CONDITIONS OF APPROVAL:

Engineering - Final Plat Checklist

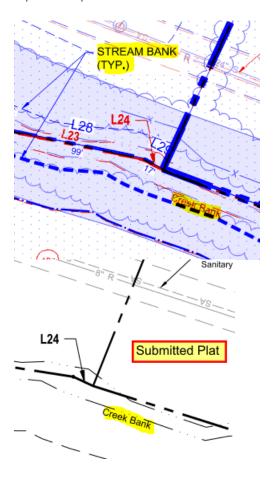
joe.marlo@franklintn.gov Comment not addressed on plat. Lines showing bottom (not top) of bank still shown on plat.

Applicant to show Stream Bank lines as depicted on associated Site Plan for Stream Valley Section 13 (COF 4579). (Blue represents COF 4579, red represents current plat under review). Delete erroneous "Creek Bank" lines at all location that do not represent top of bank. Dimension Zone 1 Buffer from top of stream bank.

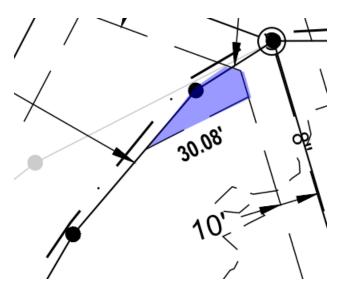
joe.marlo@franklintn.gov Comment not addressed on plat.

Label and dimension drainage easement highlighted below in Lot 432.
